## CLEVELAND NATIONAL FOREST POWER LINE REPLACEMENT PROJECTS

### MINOR PROJECT REFINEMENT REQUEST FORM

<b>Date Submitted:</b>	02-10-20	<b>Request #:</b>	044
<b>Date Approval Required:</b>	03-23-20	<b>Landowner:</b>	Various
<b>APNs:</b>	XXX-XXX-XX, and XXX-XXX-XX		
<b>Refinement from (check all that apply):</b>			
<input type="checkbox"/> Mitigation Measure	<input type="checkbox"/> APM	<input checked="" type="checkbox"/> Project Description	<input checked="" type="checkbox"/> Drawing <input checked="" type="checkbox"/> Other
<b>Identify source (mitigation measure, project description, etc.):</b>			
<p>As described in the Final Environmental Impact Report/Environmental Impact Statement (EIR/EIS) for the Cleveland National Forest Power Line Replacement Projects (Project), removal of Transmission Line (TL) 626 from service (also referred to as TL626RFS) and the conversion of TL626 from 69 kilovolt (kV) to 12 kV are part of the Environmentally Superior Alternative and the Federal Preferred Alternative. As shown in Figure E-1: Environmentally Superior Alternative (CEQA) and Federal Preferred Alternative (NEPA) of the Final EIR/EIS, the 69 kV to 12 kV conversion on TL626 includes northe

**Attachment B:**  
**Comparison Map**  
**TL626 Conversion South**  
**Map 2 of 40**

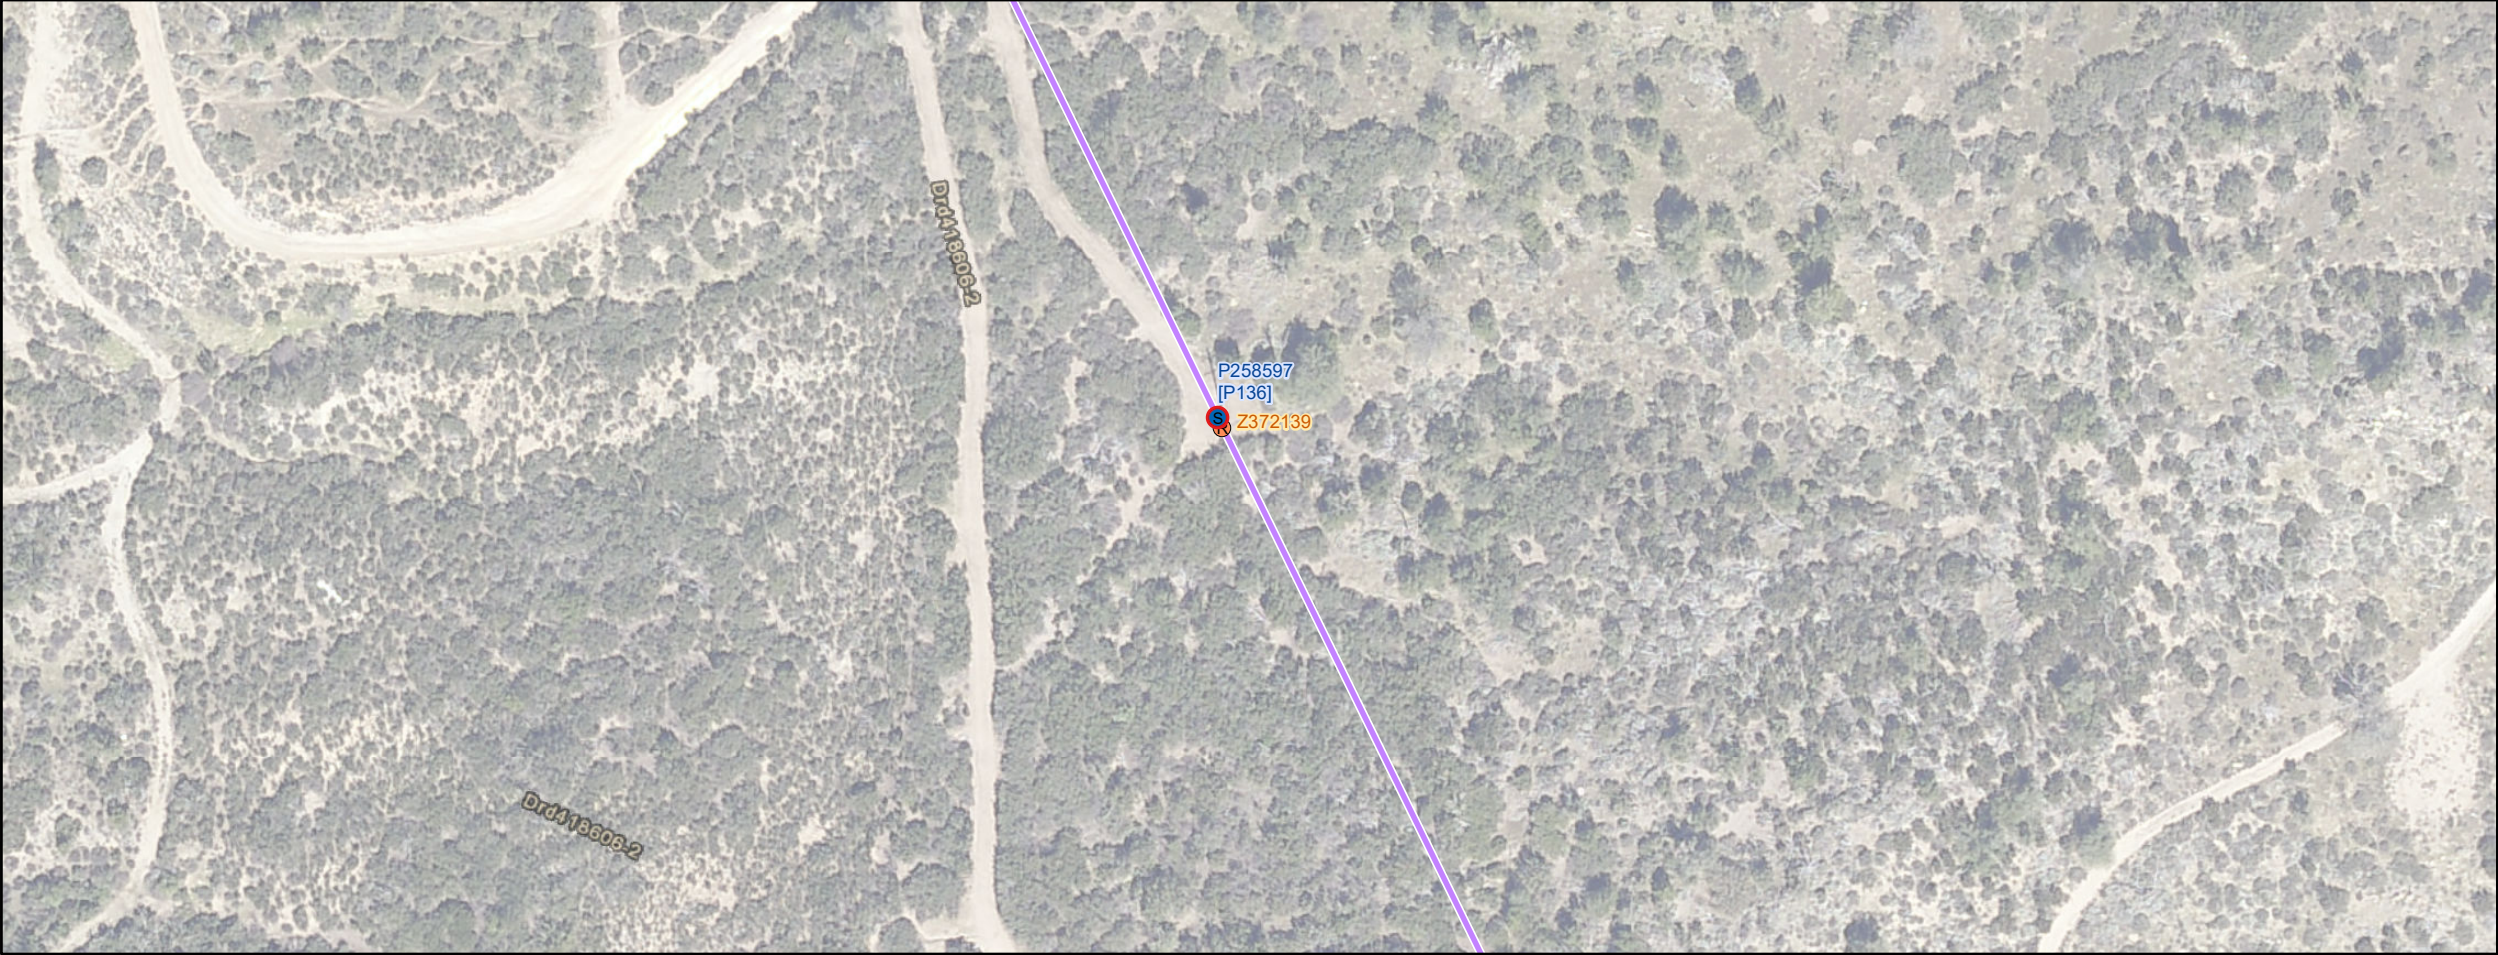
**Final Design**  
**NTP #26**  
 Removal  
**MPR #44**  
 Wood-to-Steel Replacement 12 kV Only  
 Wood-to-Steel Replacement

**Attachment B:  
Comparison Map  
TL626 Conversion South  
Map 4 of 40**

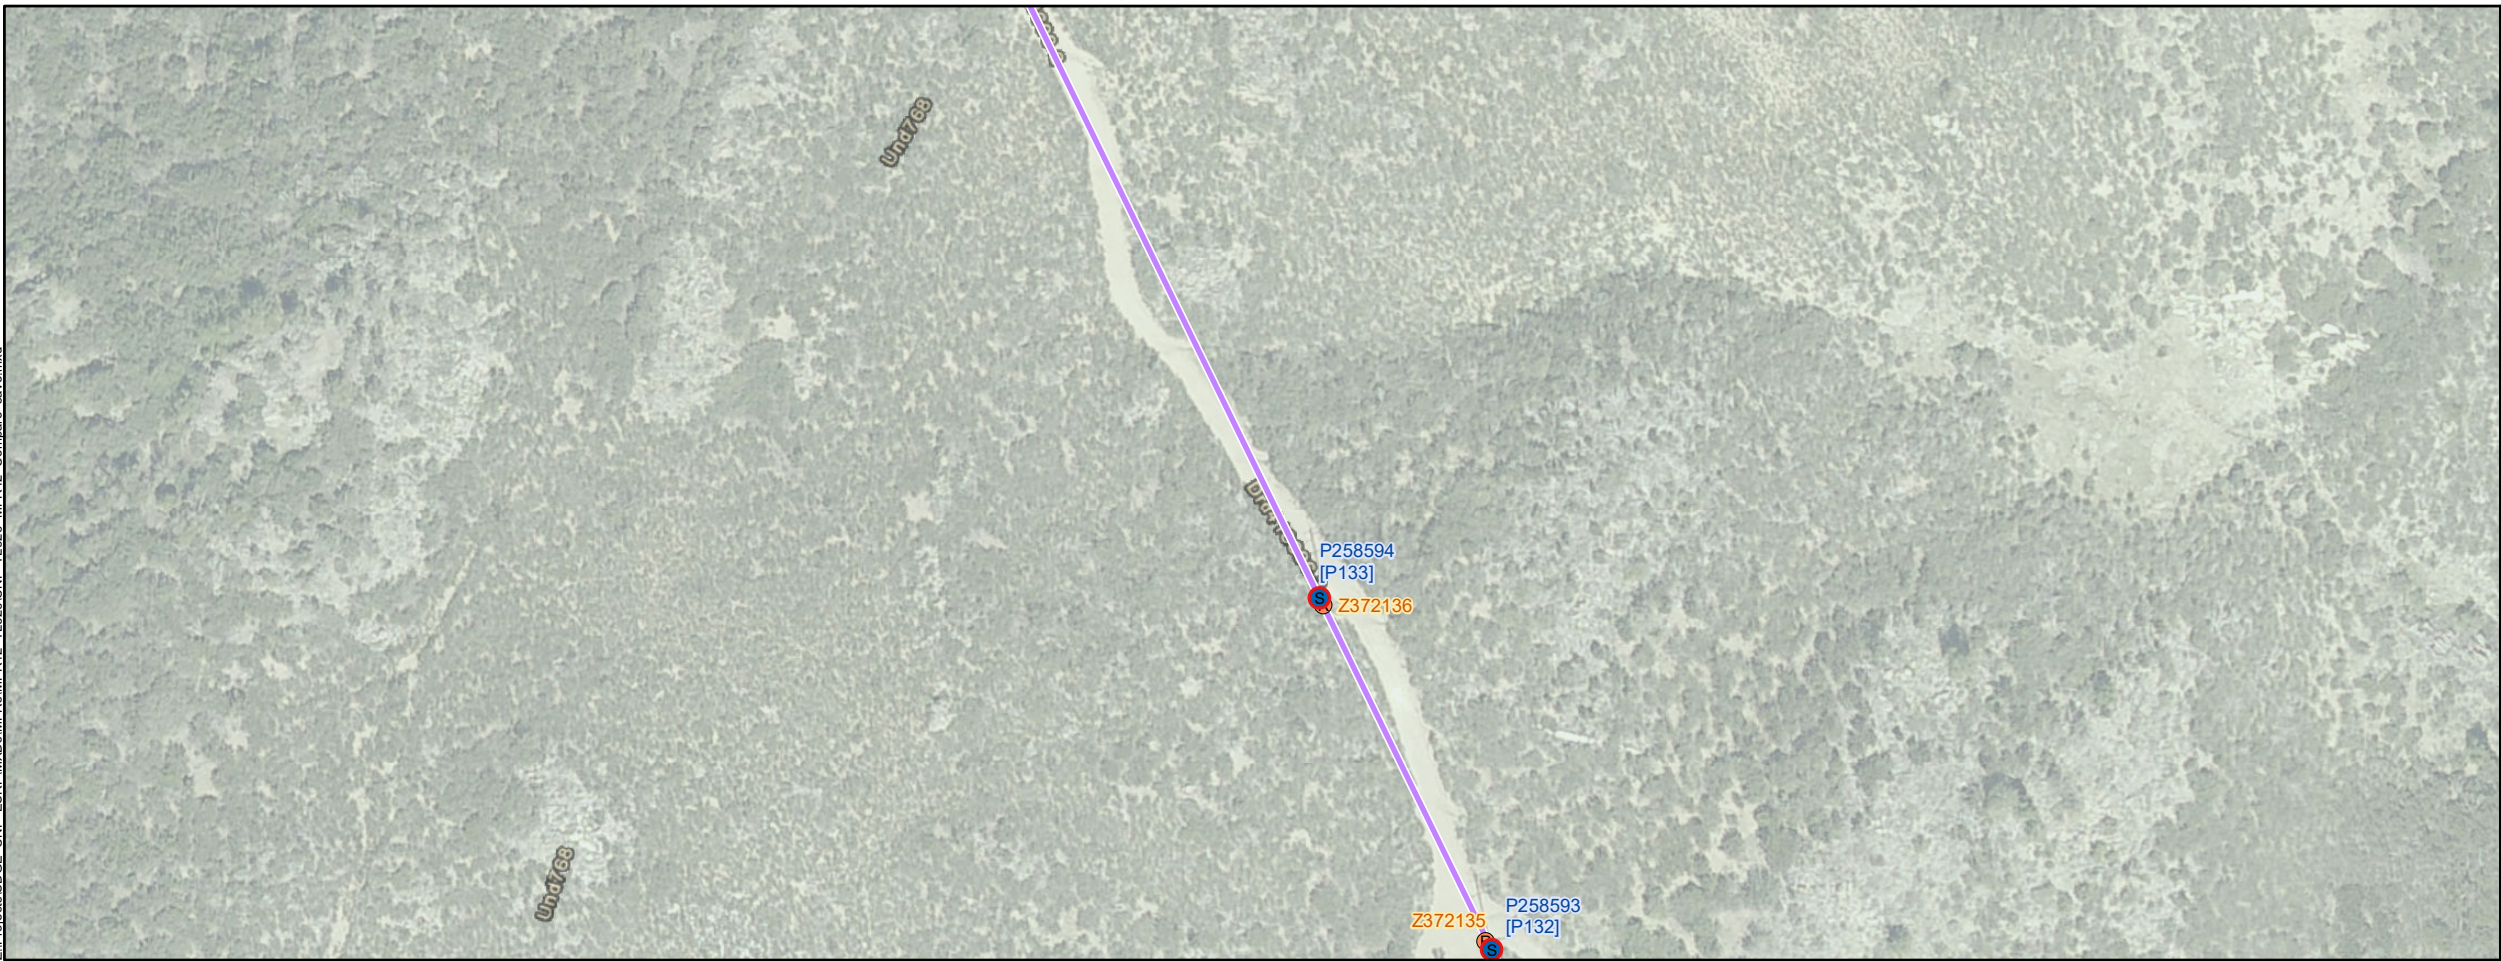
**MPR #44**

-  Wood-to-Steel Replacement 12 kV Only
-  Wood-to-Steel Replacement

Attachment B:  
Comparison Map  
TL626 Conversion South  
Map 5 of 40

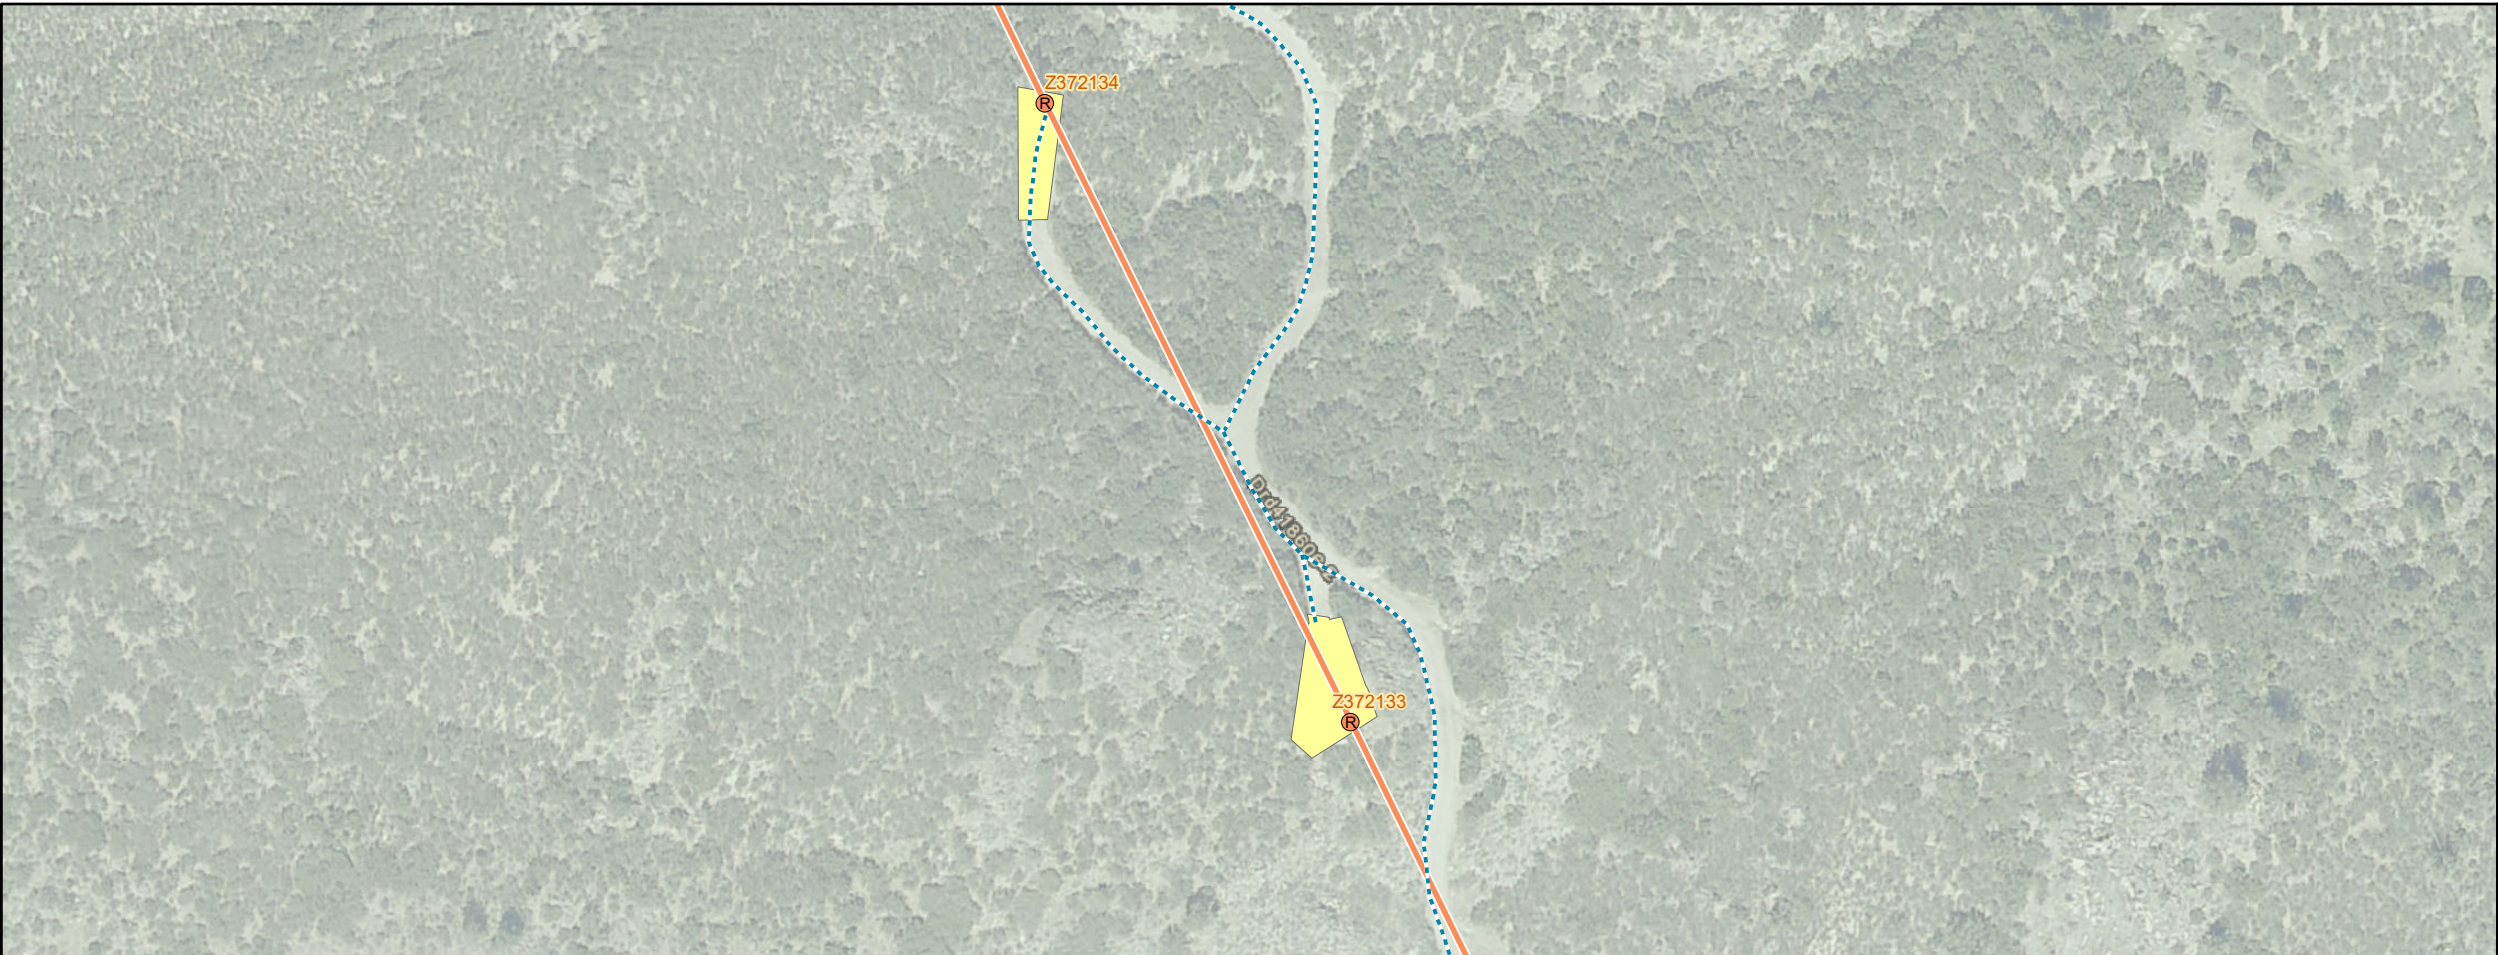
MPR #44

Wood-to-Steel Replacement 12 kV Only

Wood-to-Steel Replacement

**Attachment B:  
Comparison Map  
TL626 Conversion South  
Map 6 of 40**

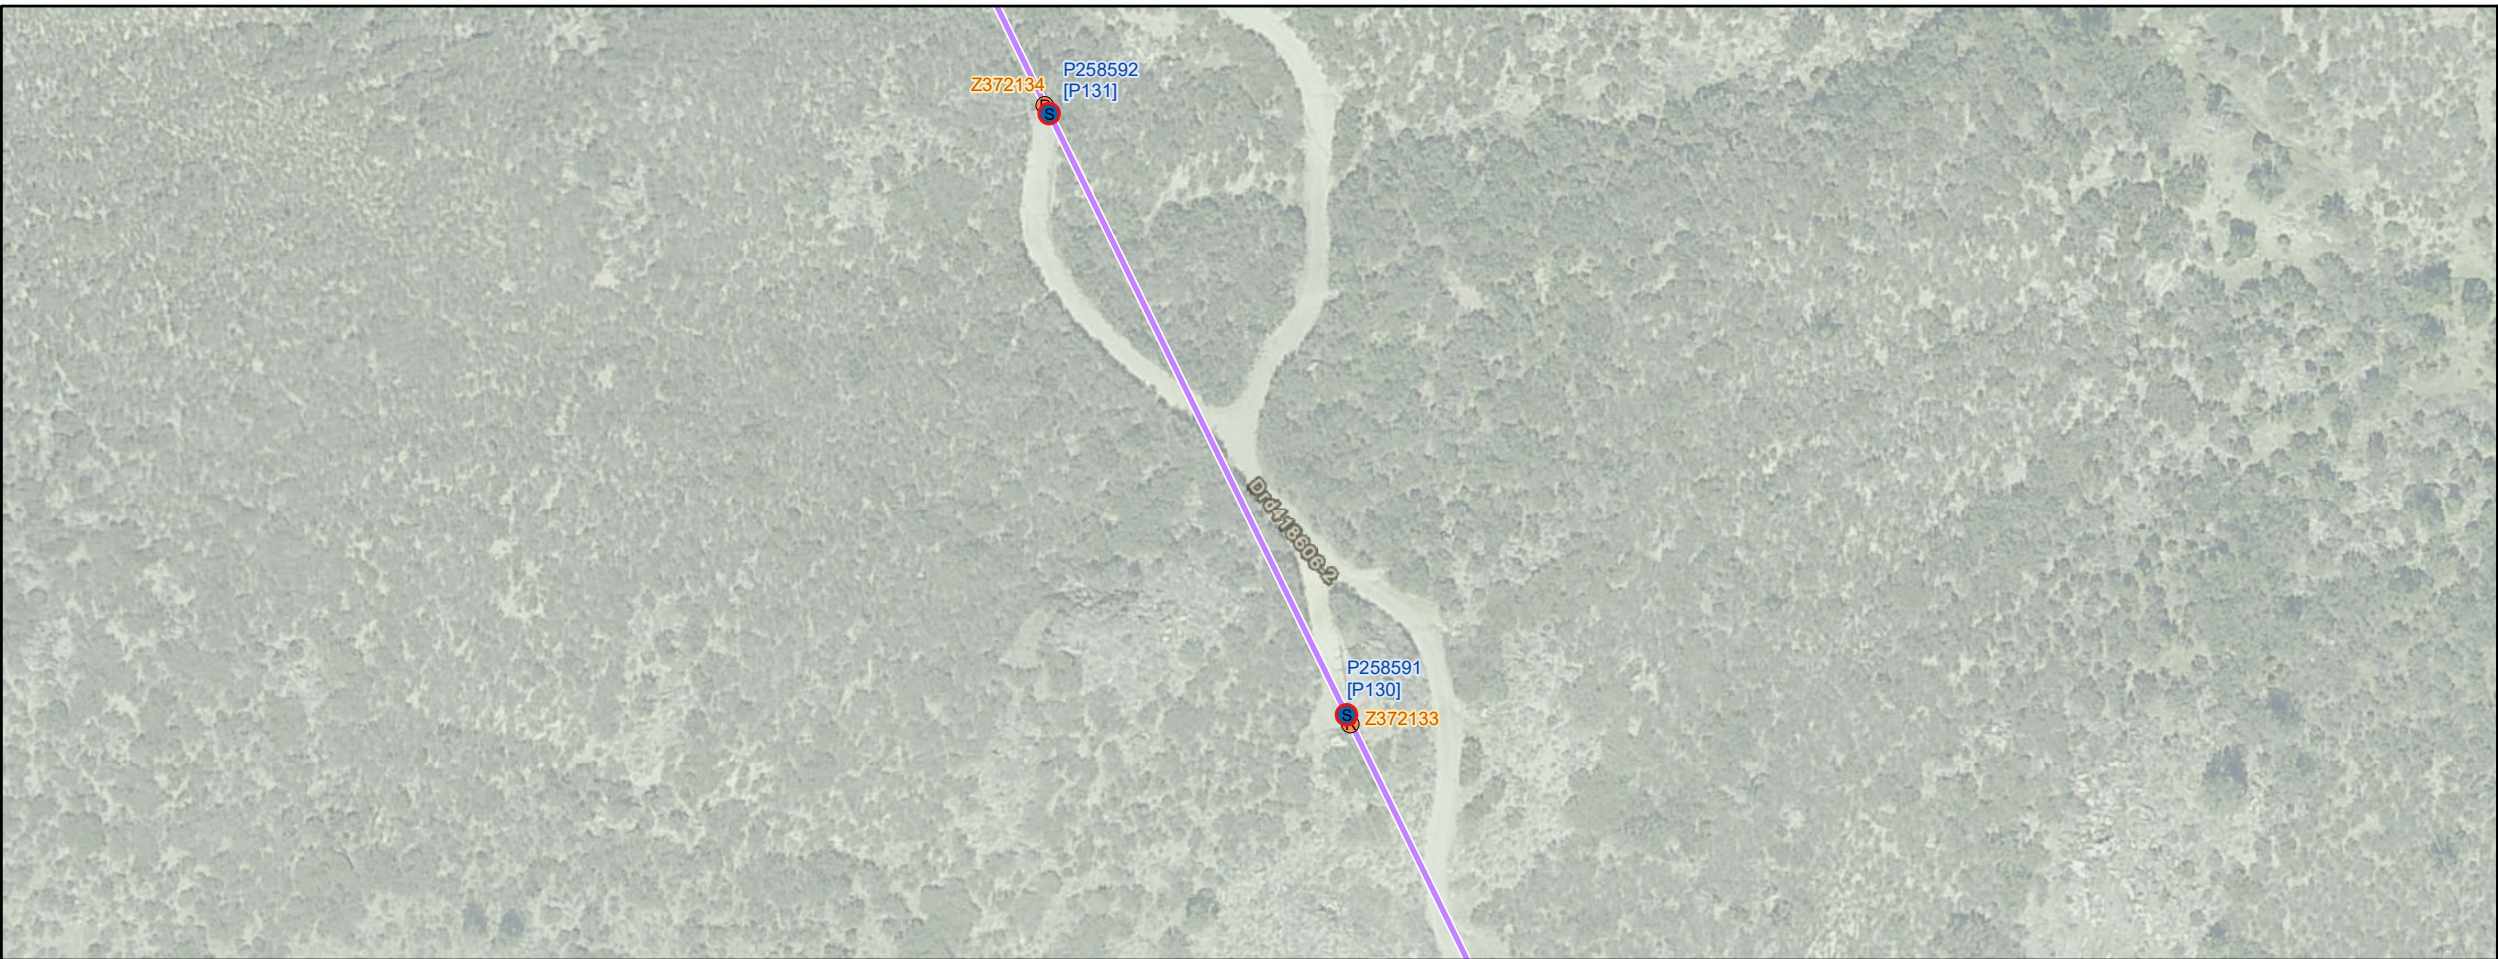
- NTP #26**
-  Removal
- MPR #44**
-  Wood-to-Steel Replacement 12 kV Only
-  Wood-to-Steel Replacement
-  U.S. Forest Service
